## The Hirwaun Generating Station Order

# APPLICATION TO MAKE A NON MATERIAL CHANGE TO THE HIRWAUN GENERATING STATION ORDER

<b>PINS Reference Number:</b>	EN010059
<b>Document Reference:</b>	NMC
<b>Regulation Number:</b>	Regulation 4
<b>Author:</b>	Hirwaun Power Limited

GAS TURBINE GENERATOR PLAN & ELEVATIONS Reg5(2)(o)

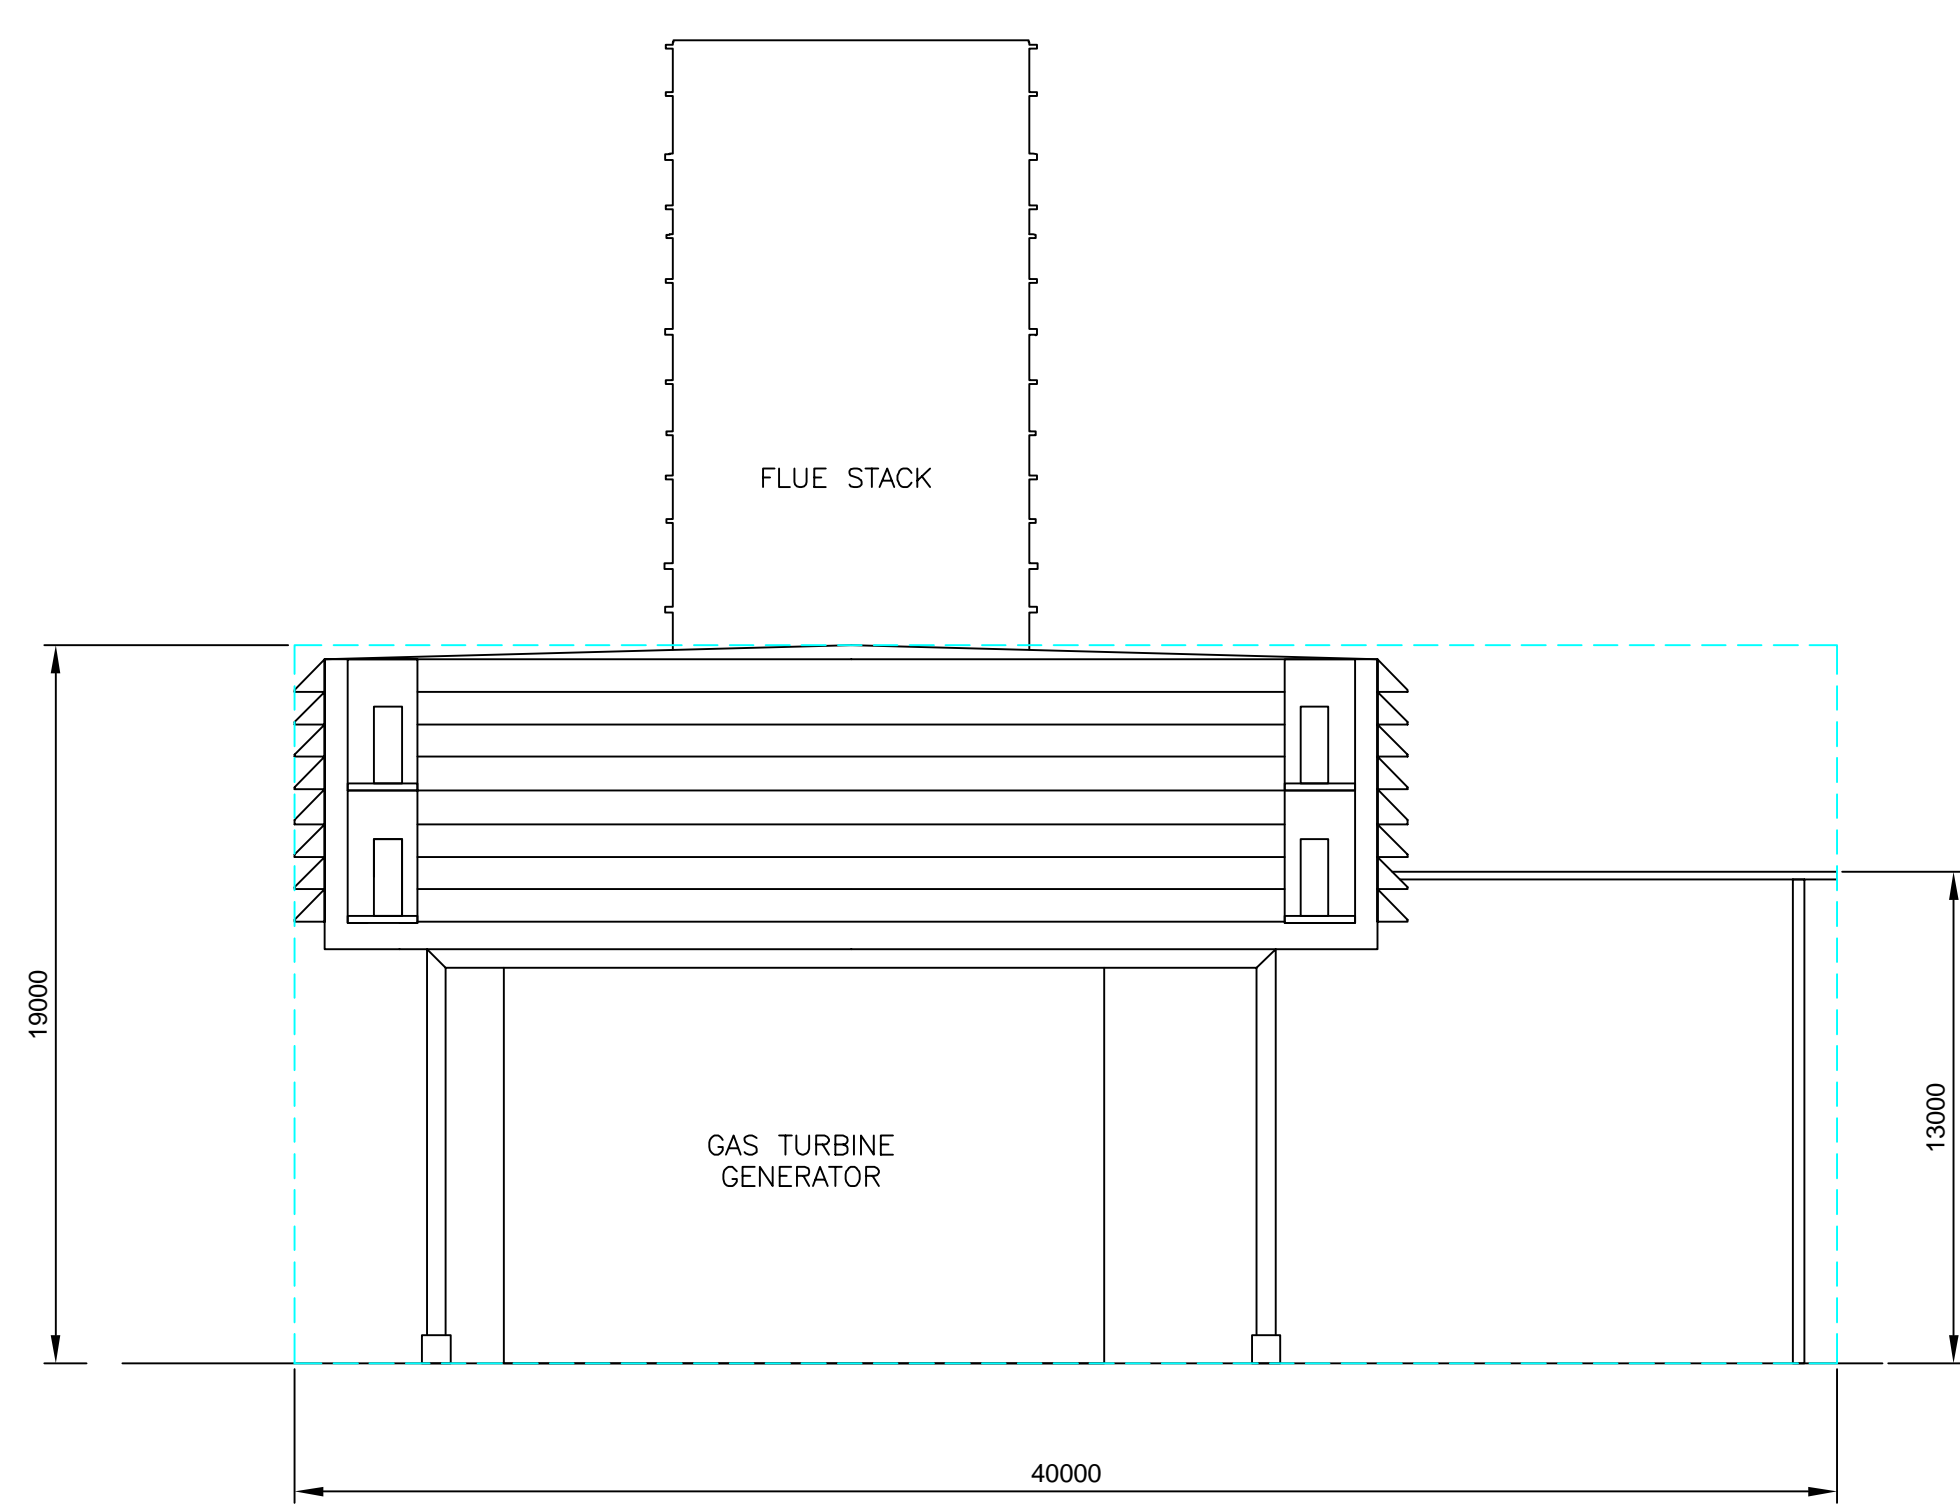
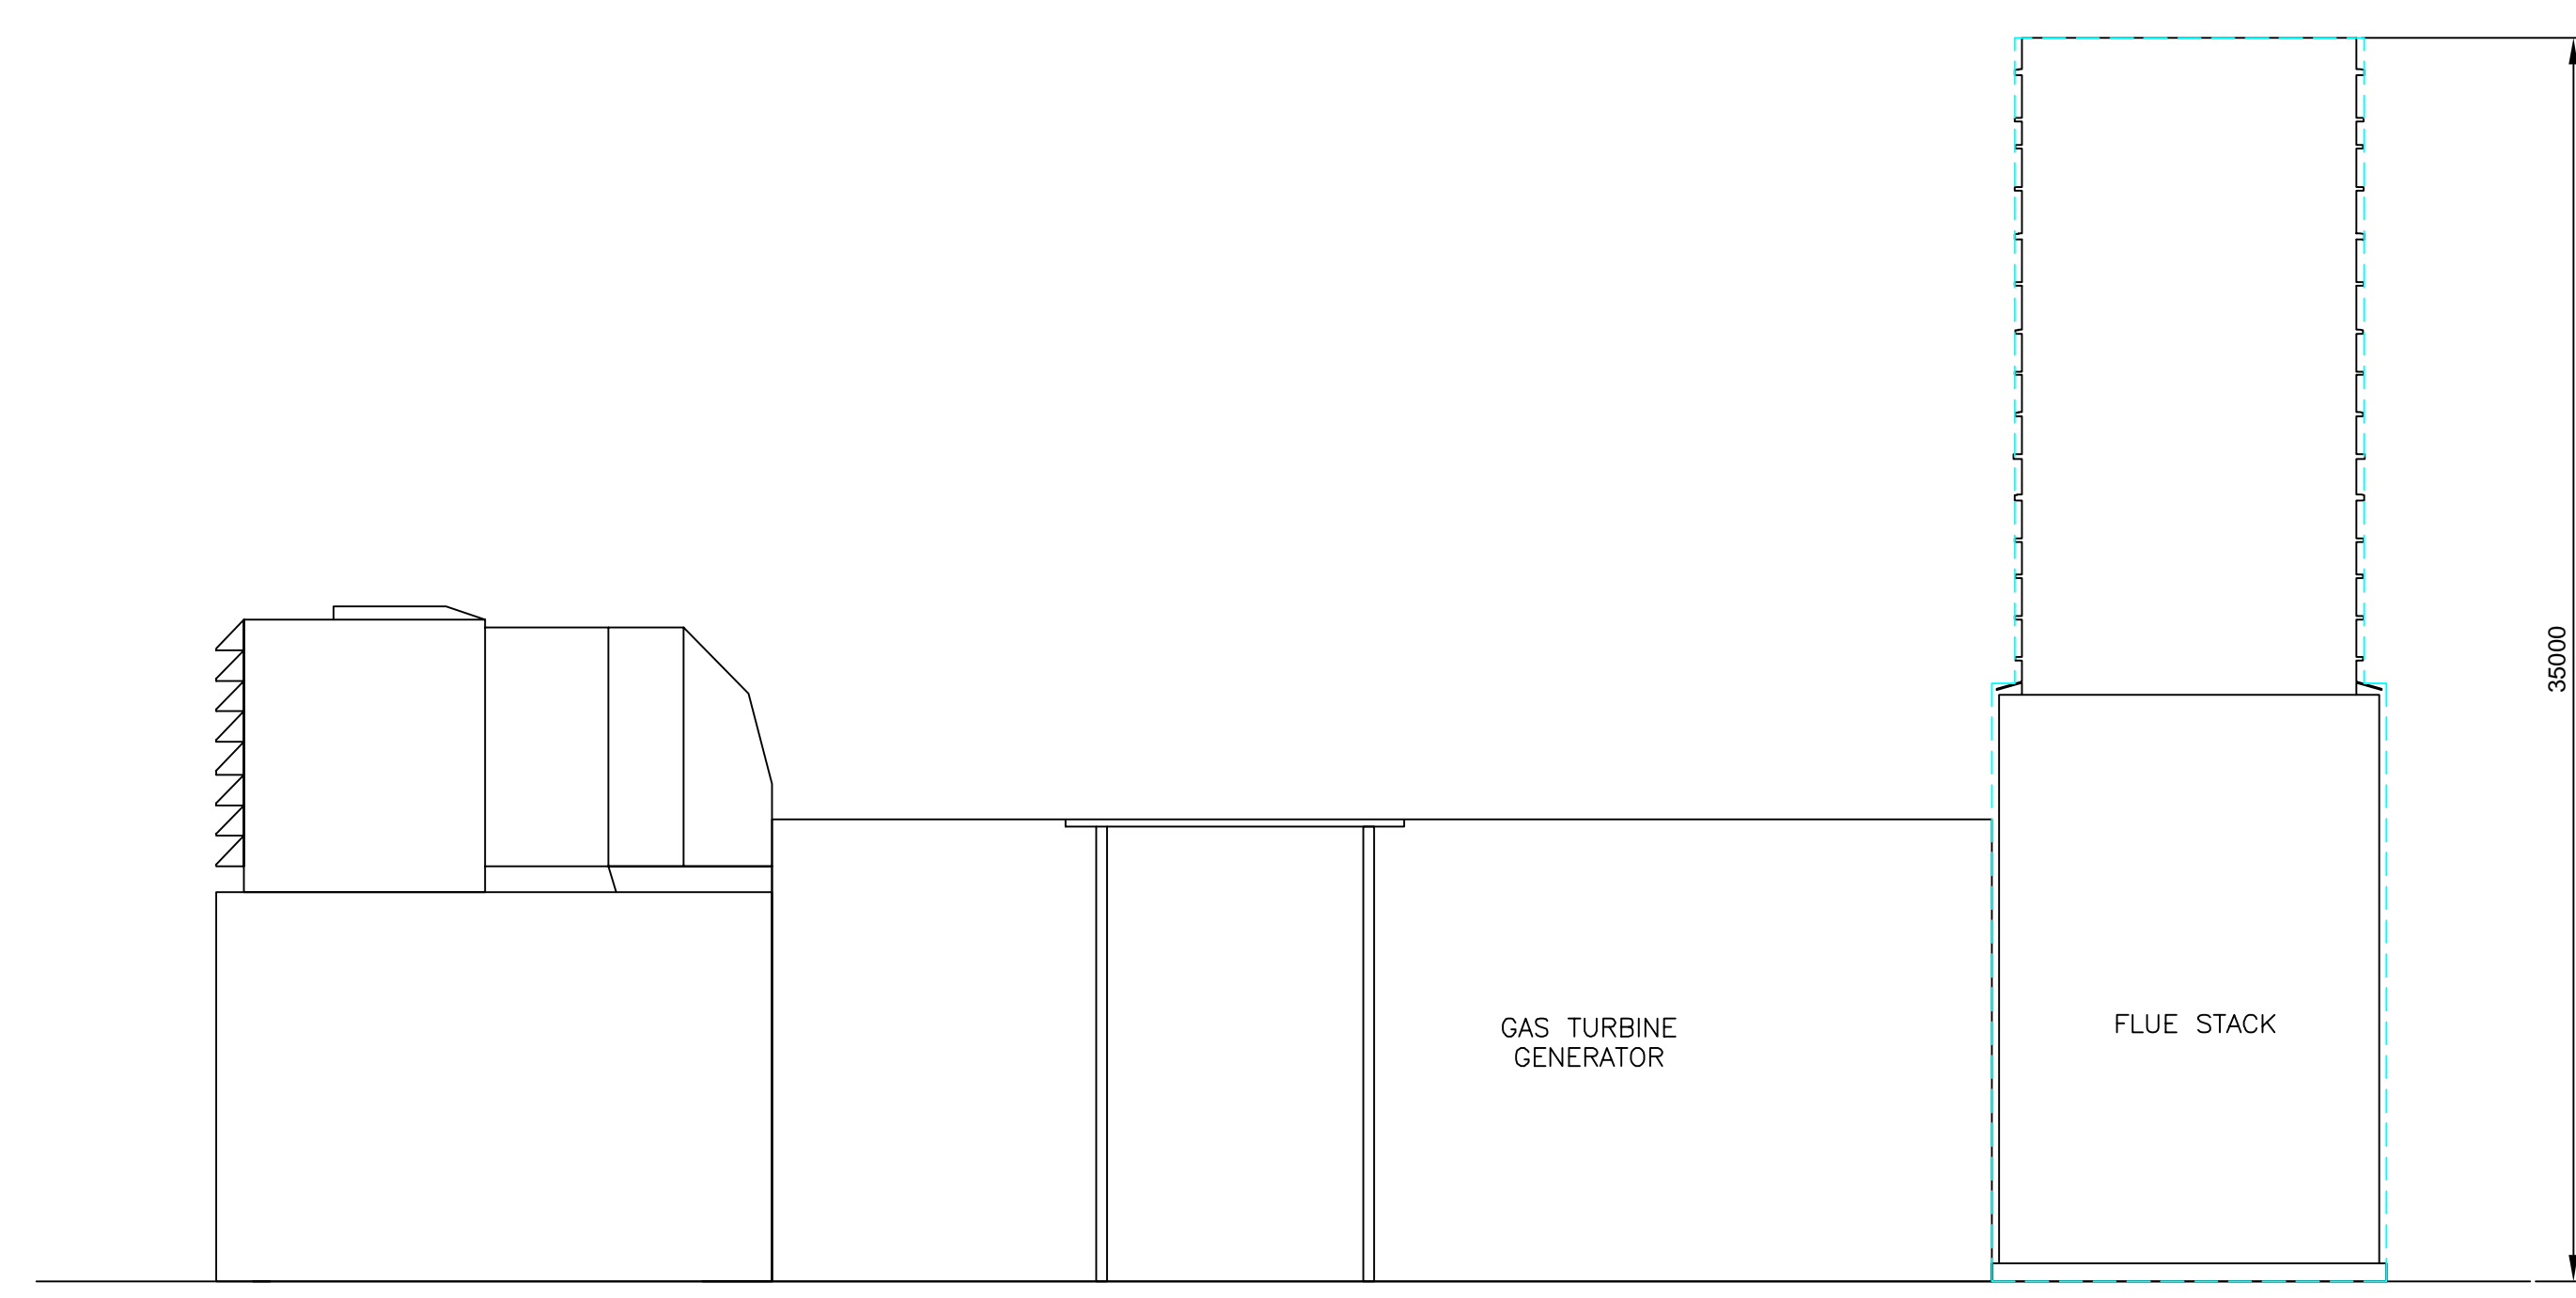
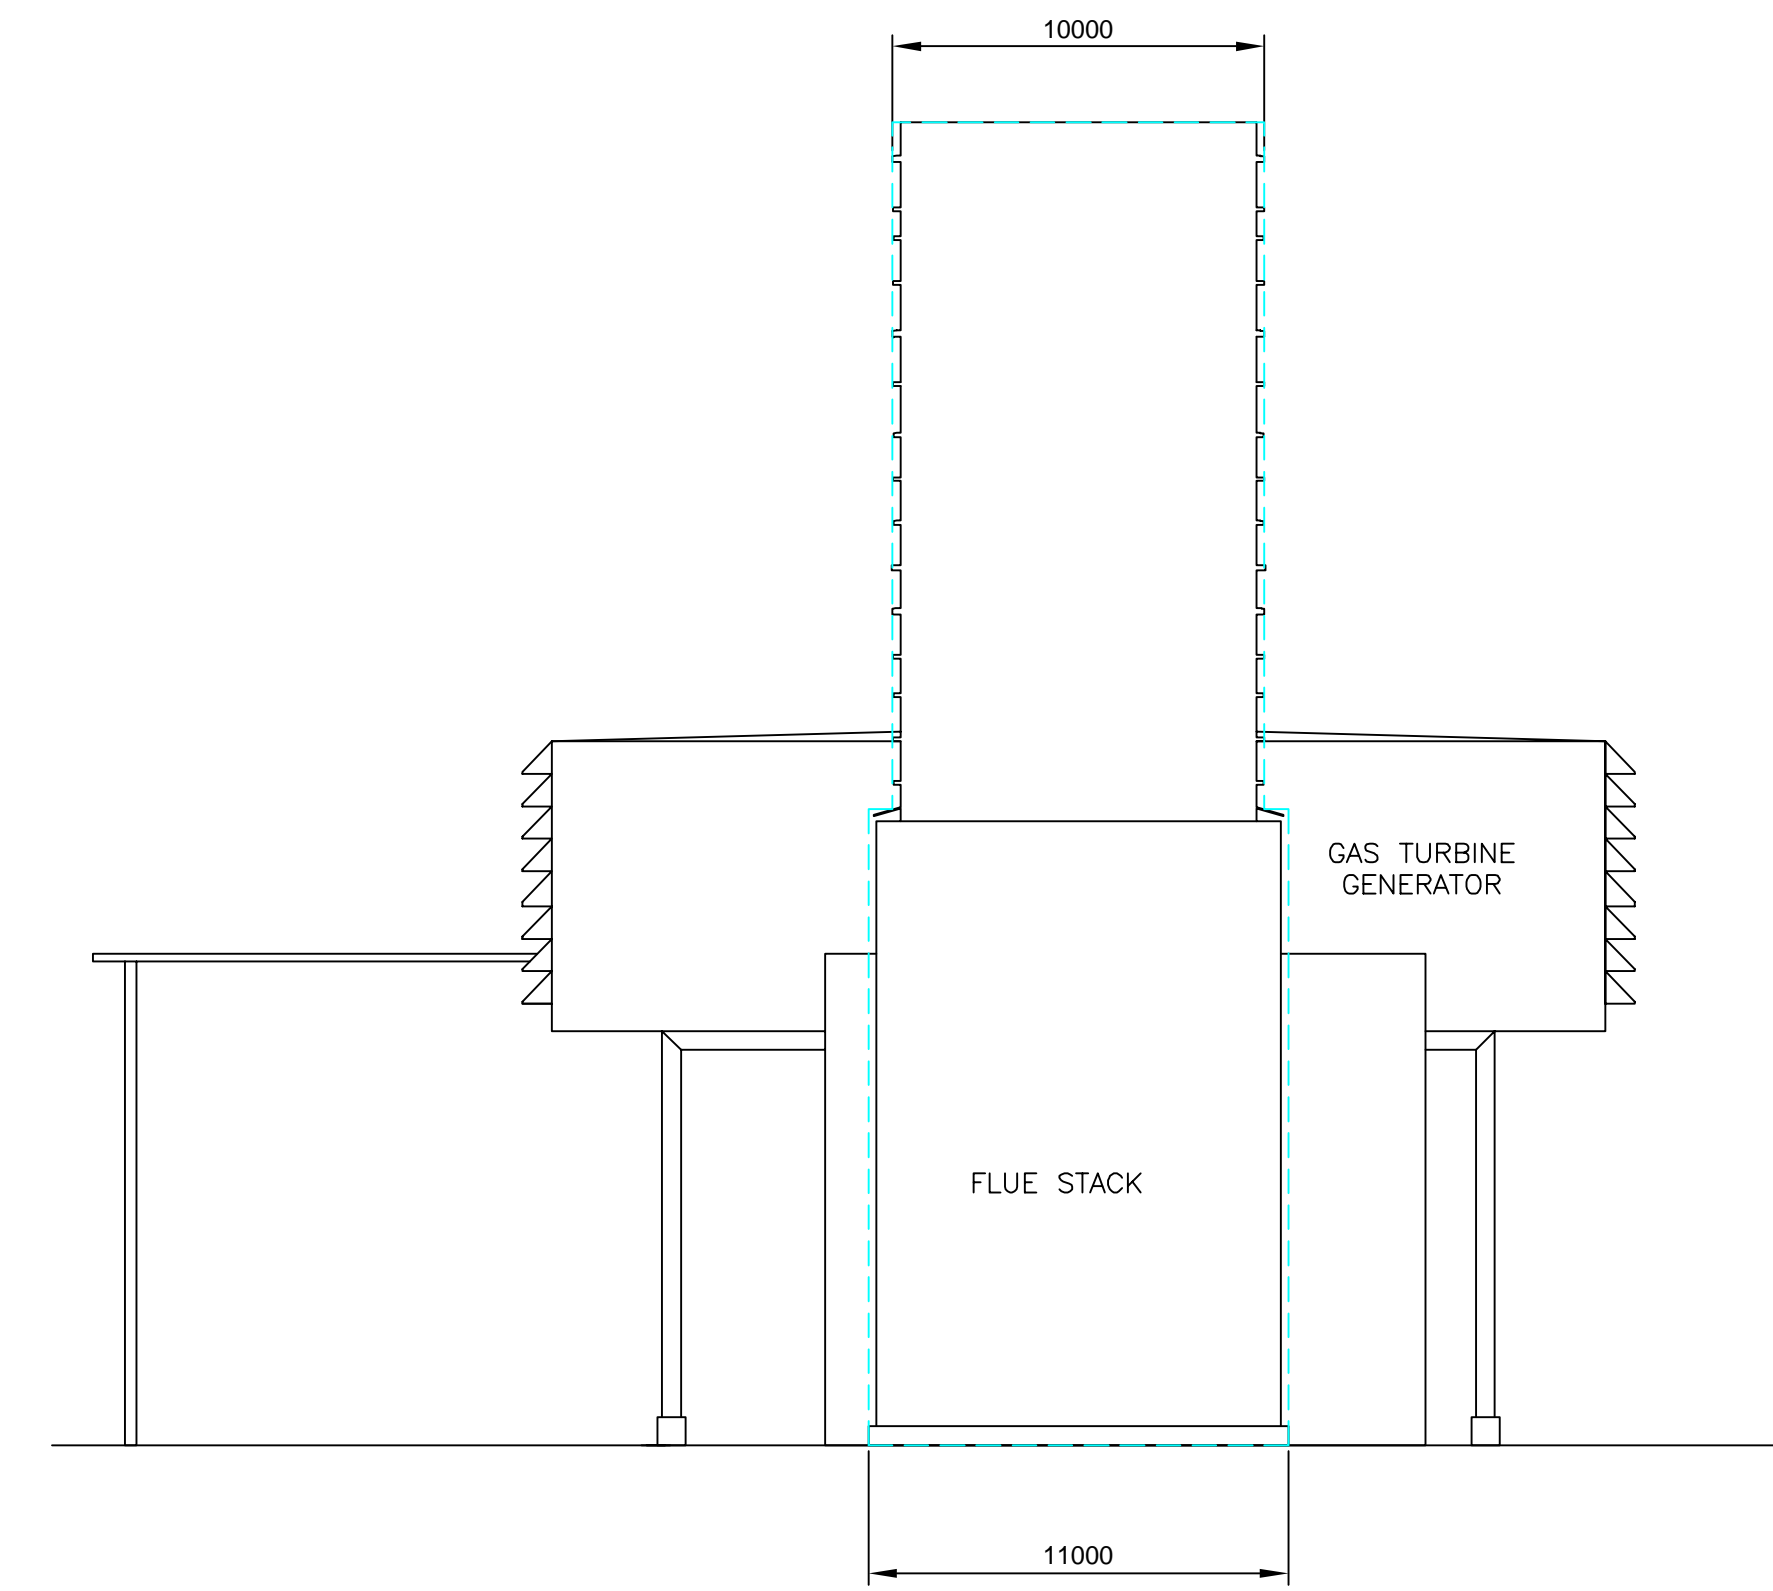
4.2.3 In summary, **for the one GTG scenario only**, there is a need to increase the length of the GTG from a maximum of 30 metres to 50 metres to accommodate the diffuser system elements of the GTG and the width from a maximum of 30 metres to 40 metres to accommodate the lube oil system. This would involve a change to Table 2 in Requirement 4, Schedule 2 of the Order. However, there would be no change in the overall footprint of the Power Generation Plant as show in Figures 5 and 6 of the Environmental Report (see Appendix Two).

(b) Figures 1, 2, 4, 5 and 6 of the Environmental Report show the proposed single GTG scenario and the proposed changes.

<b>Change Number</b>	<b>Building or Structure</b>	<b>Summary of what currently is authorised under the Order</b>	<b>Suggested Change</b>
One	Gas Turbine Generator (GTG)	<p>Table 2, Requirement 4, Schedule 2:</p> <p>Each gas turbine generator (where one or two gas turbine generators are constructed) (Part of numbered work 2A):</p> <p>Maximum height: 19 metres above 211 metres AOD</p> <p>Maximum length: 30 metres</p> <p>Maximum width: 30 metres</p>	<p>Amend Table 2, Requirement 4, Schedule 2 as set out in Appendix Four so as to permit the following parameters for a single GTG scenario:</p> <p>Maximum height: 19 metres above 211 metres AOD</p> <p>Maximum length: 50 metres</p> <p>Maximum width: 40 metres</p>
Two	Flue Stack	<p>Table 2, Requirement 4, Schedule 2:</p> <p>Each exhaust gas emission flue stack (part of numbered work 2A):</p> <p>Maximum height: 35 metres above 211 metres AOD</p> <p>Minimum height: 30 metres above 211 metres AOD</p>	<p>Amend Table 2, Requirement 4, Schedule 2, as set out in Appendix Four so as to permit the following parameters for a single GTG scenario:</p> <p>Maximum width: 11.0 metres up to and including a height of 16.5 metres above 211m AOD and 10 metres from a height of 16.5 metres above 211m AOD to a height of 35.0 metres above 211m AOD "</p>
